December 17, 2004

Dear ZODIAC XL builder:

ZENITH AIRCRAFT COMPANY

6G1-5 FORK DOUBLER
t=3/16" 6061-T6 (1 REQ'D)
COLD BEND

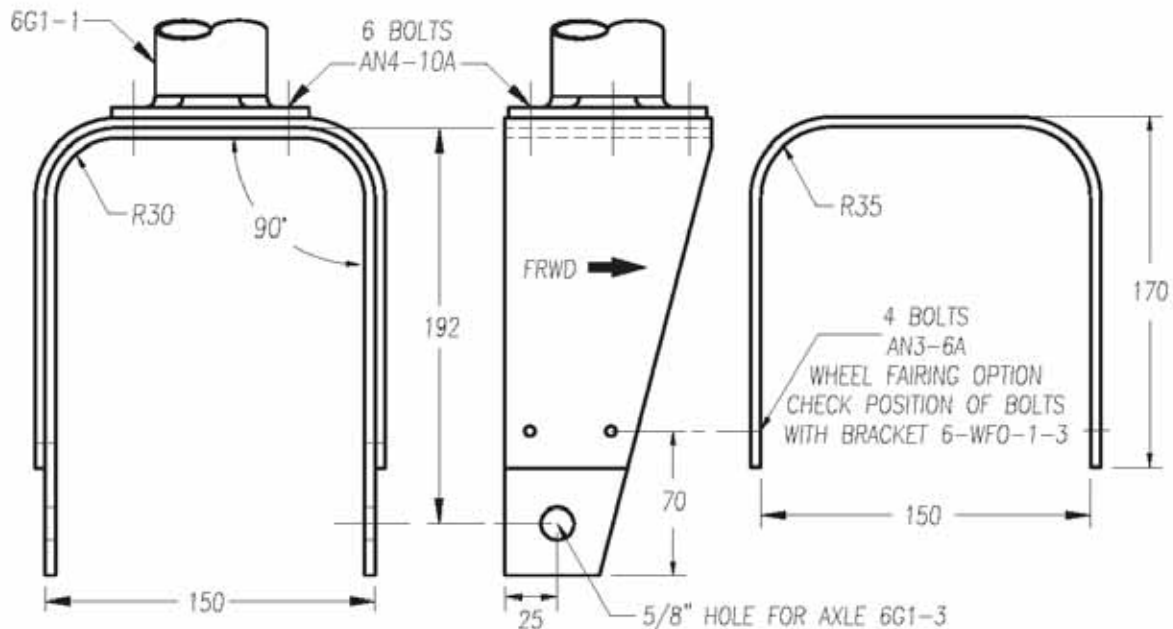
Upon inspection of several aircraft it's come to my attention that the original nosewheel fork of the Zodiac XL is quite flexible with side loads, and that cracks may begin to form in the nosewheel fork bend radius over time or with excessive side loads. If a nosewheel fairing is installed it may be difficult to inspect for cracks.

I recommend that a nosewheel fork doubler be installed as shown below:

The nosewheel fork doubler, part no. 6G1-5, can be ordered from Zenith Aircraft Co. for \$32.50 with the installation hardware, and for \$40.00 including shipping and handling within the USA.
